Re: Highland Livestock and Land Co., Ltd. Water Right Permit Nos. 63-33960, 63-34429, and 63-34876 Beneficial Use Field Examinations Response to Additional Information Request

RE: Water Right Permits No. 63-33690, 63-34429, and 63-34876

SUBJECT: Licensing Review of Water Right 63-33960 and 63-3487

RE: Field exam report for water right permits 63-33960, 63-34429, and 63-34876.

Permit 63-33960:

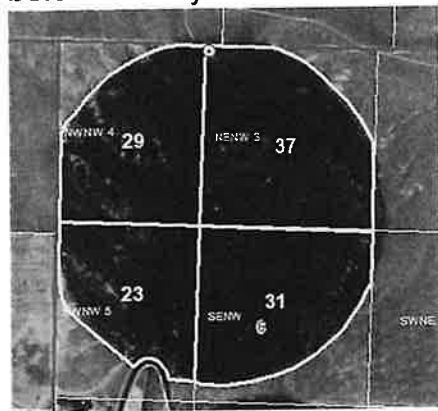
The field examiner requested that this permit be licensed as having a permissible place of use with the full acres and diversion rate authorized by the permit. It appears as though the entire pivot has been irrigated, since the water was first put to beneficial use. The system does not appear to have been operated by using each water right individually using the full diversion rate authorized by each right. Based on the permit development, we will not be able to issue a license on this permit for more than an average diversion rate per acre for the 102 acres authorized by this right. This right will be recommended at a diversion rate of 1.64 cubic feet per second and the 459 acre-feet of annual volume based on the diversion rate and volume actually applied to the 102 acres irrigated under this right.

An amendment can be filed to allow this right to irrigate any 102 acres in a single season within the 120 acre pivot described in his field report. This will allow you to move the acres around each irrigation season to cover the most important 102 acres if water right 63-34876 is curtailed to ensure you are irrigating the 102 acres best served by the system. If you wish to have this flexibility, you will need to sign the amendment and return it with the \$100.00 fee.

If you don't wish to sign the amendment and return the \$100.00 fee with the amendment, we will need to license the water right as it was permitted. The following maps show how we can license this water right with the amendment and without the amendment.

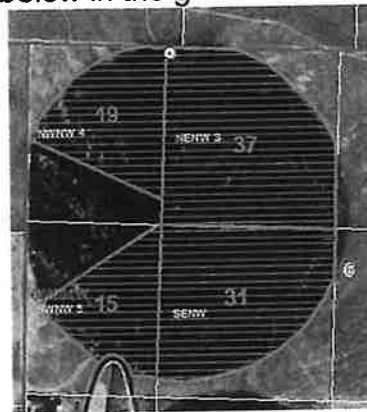
With the amendment, you will be able to irrigate 102 acres within the 120 acre area shown below in the yellow border.

Permit 63-34876:

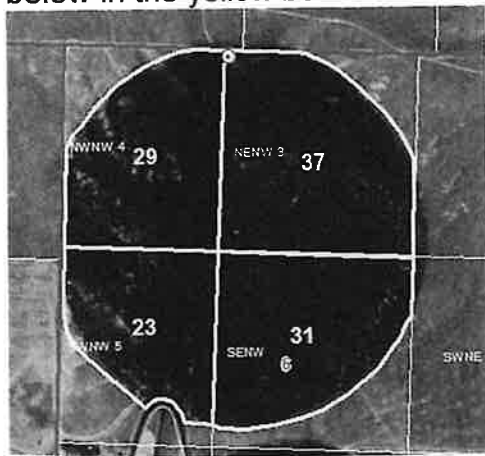
The field examiner requested that this permit be licensed as having a permissible place of use with the full acres and diversion rate authorized by the permit. As stated above, we will not be able to give the full diversion rate and acres authorized above, because the full pivot has never been operated in a manner to separate out the individual rights. The license for this permit will authorize 0.29 cubic feet per second, 81 acre-feet of annual volume, and 18 acres developed in this system in addition to the diversion rate, volume, and acres authorized by water right 63-33960.

An amendment will allow you to move the 18 acres associated with this right to different areas within the pivot. You will be able to adjust the location that will ensure the best use of the land if a call limits this right or water right 63-33960. In order to have this flexibility, you will need to sign the enclosed amendment for water right 63-34876 and return it with a \$100.00 fee.

If you don't wish to sign the amendment and return the \$100.00 fee with the amendment, we will need to license the water right as it was permitted. The following maps show how we can license this water right with the amendment and without the amendment.

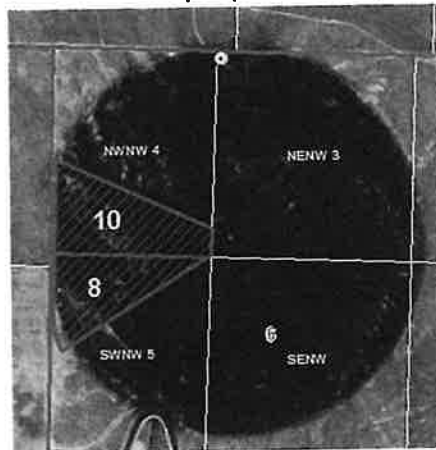
With the amendment, you will be able to irrigate 18 acres within the 120 acre area shown below in the yellow border.

Permit 63-34429:

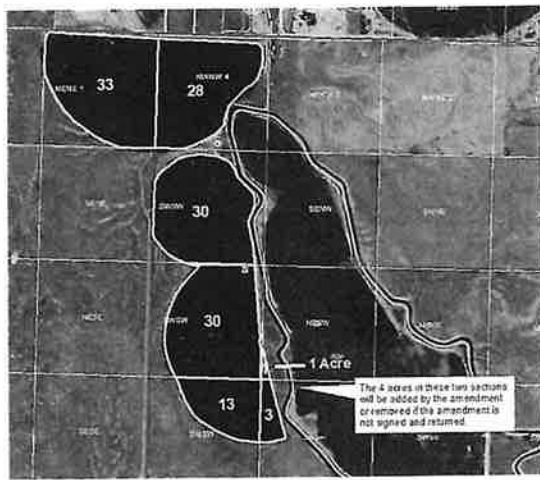
The field examiner requested that the acres originally authorized by this permit be adjusted to cover 4 acres in the NE $\frac{1}{4}$ SW $\frac{1}{4}$ and the SE $\frac{1}{4}$ SW $\frac{1}{4}$ of Section 2 in Township 5 North, Range 4 West. The 4 acres were not included on your original permit, so the certified water right examiner requested that the permit be amended to include these lands. The certified water right examiner also provided documentation that you have entered into an agreement to irrigate those 4 acres. Please see the map below for identification of the 4 acres in question:

The 4 acres shown on the southeastern side of the southernmost pivot are the 4 acres that need to be added to the permit by an amendment if they are going to continue to be irrigated. If you choose not to amend this water right, we will remove these acres from the proposed license.

If you choose not to sign the amendment for permit 63-34429, we will remove the 4 acres from the licensing of this permit, which will reduce the license to 2.68 cubic feet per second, 603 acre-feet for the irrigation of the remaining 134 acres.

Dave Little
12NC 5 stage
925 gpm @ 400 TDH

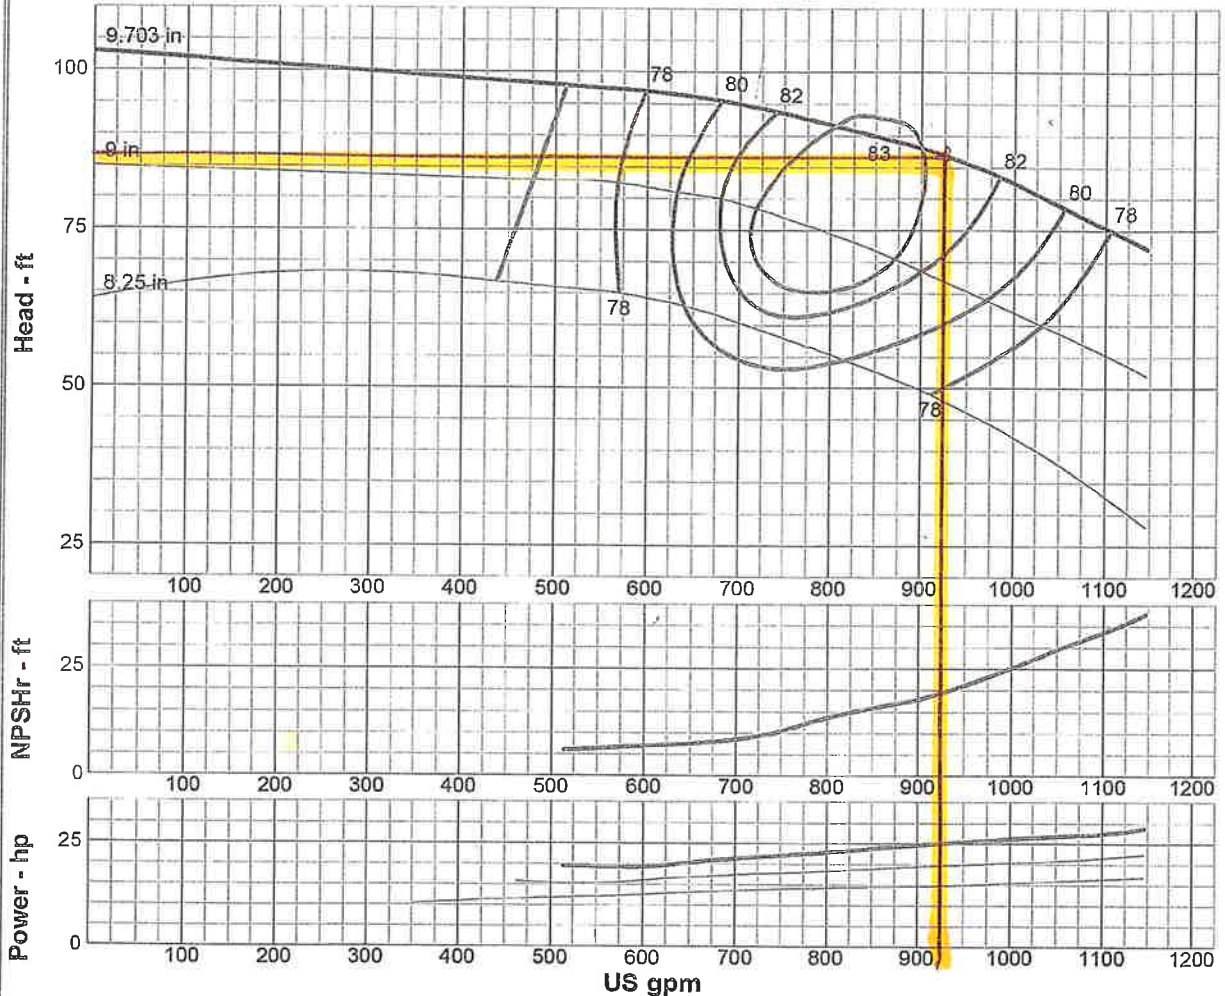
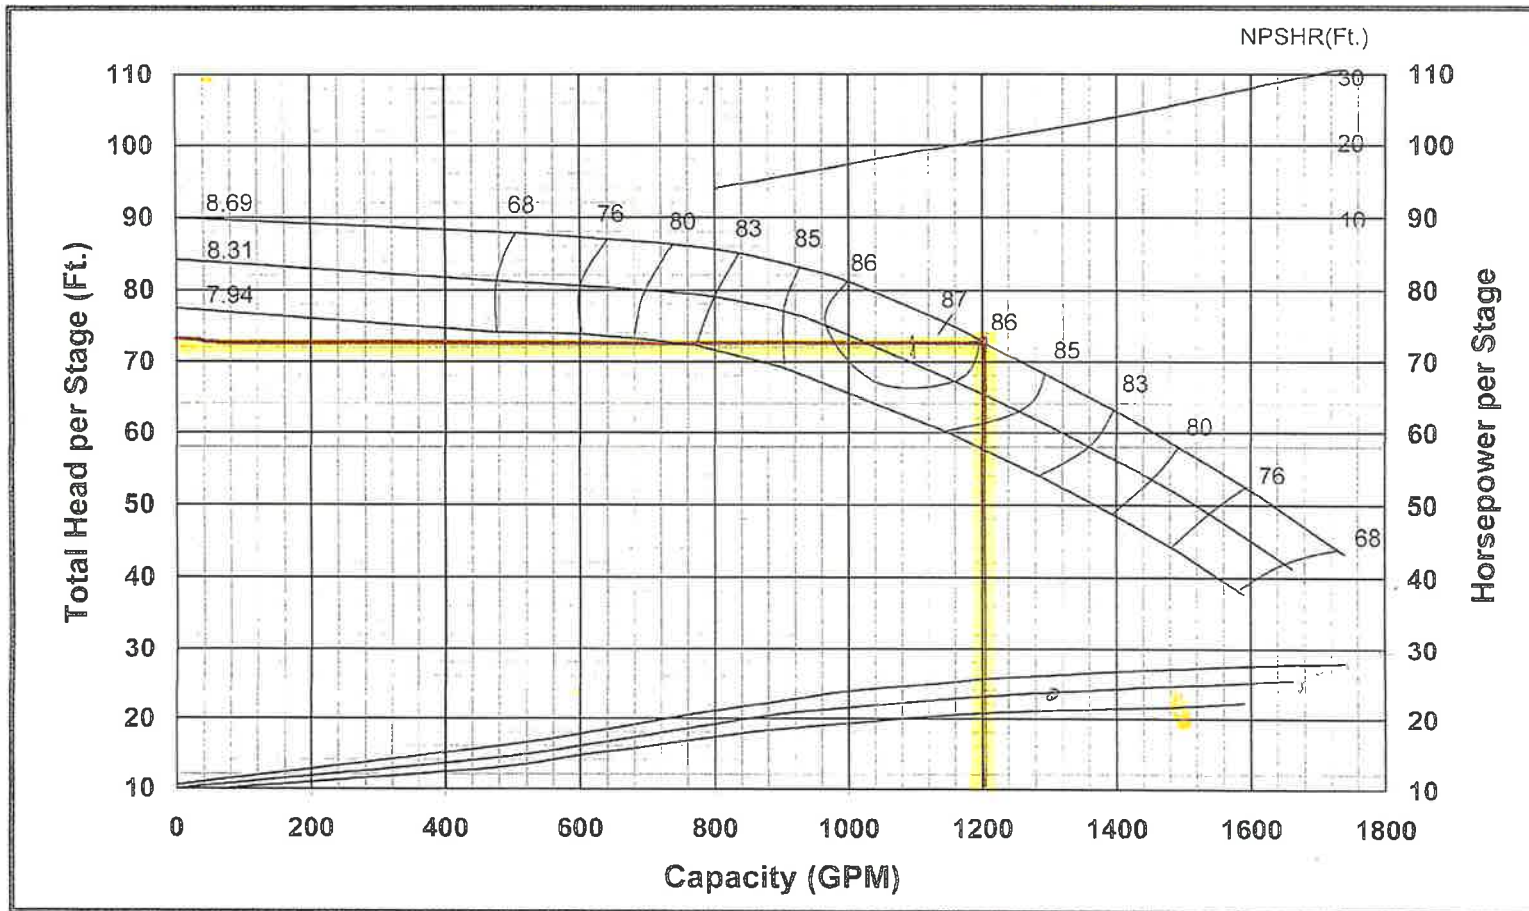
In my September 21, 2020, rejection letter, I suggested that the flow rate measured by Mr. Shaw seemed to be a bit low based on the information that I had available to me at that time. Mr. Shaw provided pump curves for the well pump with his April 29, 2021, letter. In reviewing these pump curves, I am still concerned that the flow rate measured by Mr. Shaw could be less than the system could provide. Without any field notes or additional information to dispute Mr. Shaw's original measurement, I am limited to the flow rate measured by Mr. Shaw.

The 1.93 cfs measured at 10:10 am on 8-21-2020 matches closely to the 925 gpm design for this well and pump installation, copy enclosed. The pump and well have been in use since 2016 so a 6½% reduction from the design capacity of the well and pump should not be unexpected.
